26 May 2025

DA30/2025 – 118-124 Benelong Road & 72 Gerard Street, Cremorne
RFI Response

Figure 4: Drone photo locations

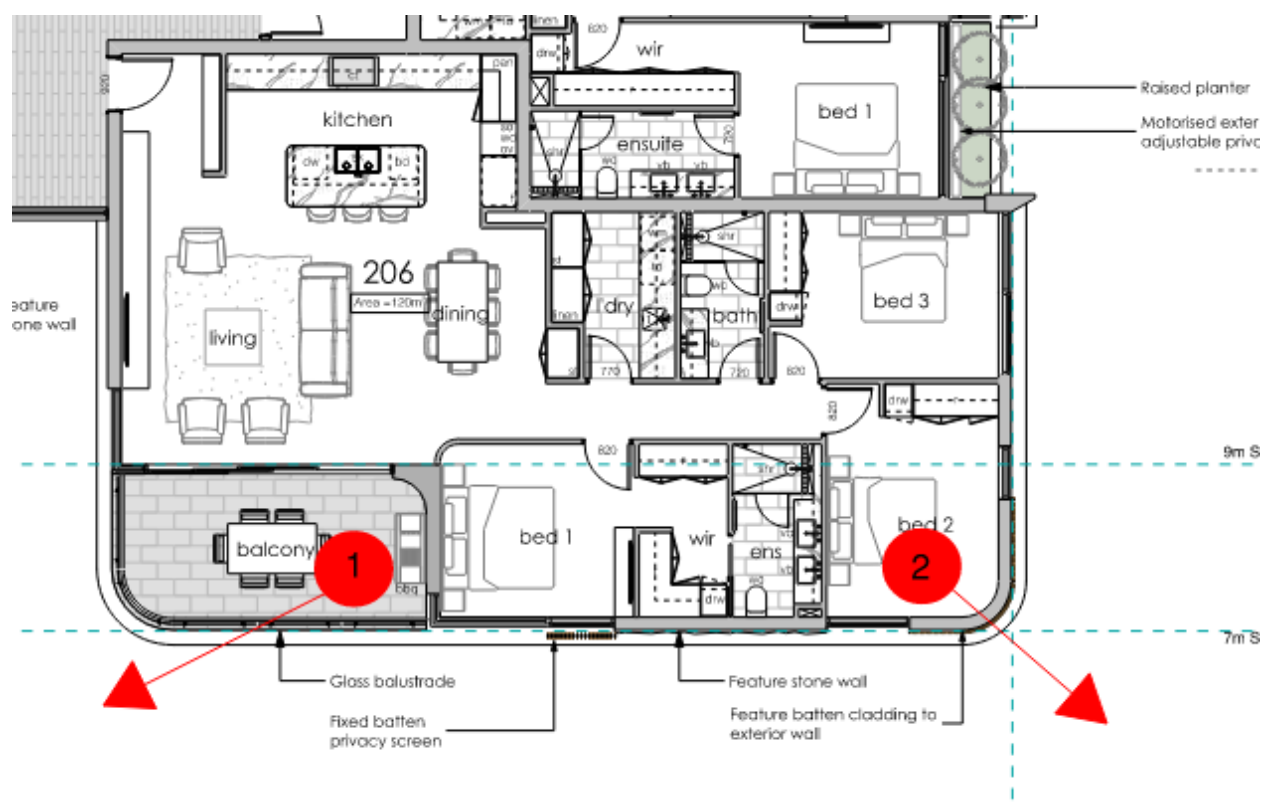
Apartments G06, 106 and 206 provide bedrooms to the building corner facing Gerard Street. The applicant explained that this was to ensure views from the living room towards the north-west, however it is not understood how this would be achieved. It should be demonstrated that genuine views and solar access are achieved to/from the living rooms. Alternatively consider relocating the living spaces to the building corner, where solar access could be maintained together with an outlook to the corner of Gerard Street and Benelong Road and oblique views towards the north-west.

Please see below photos taken via a drone, at approximately 1.6m above the FFL of Apartment 206 in the position shown in **Figure 4** below. Photo 1 is from Position 1, photo 2 is from Position 2.

As shown in Photo 1, the apartments will benefit from looking down the tree lined Benelong Road with district outlooks including views of the Chatswood skyline. Please refer to **Architectural Drawing DA.35 Solar Access** for confirmation of the solar access to these apartments.

Photo 2 has been provided to demonstrate the outlook from the proposed alternate location. As can be seen, this outlook looks into the traffic lights and traffic on Gerard St. The apartments have been designed to turn their back on this corner to minimise exposure in the main living areas to the busy road, to ensure the greatest amenity for the residents. As stated in the DEP meeting, double glazing will be provided to the apartments to minimise noise into the bedrooms located on this frontage.

As such, we do not propose to make any amendments to the design in this regard.
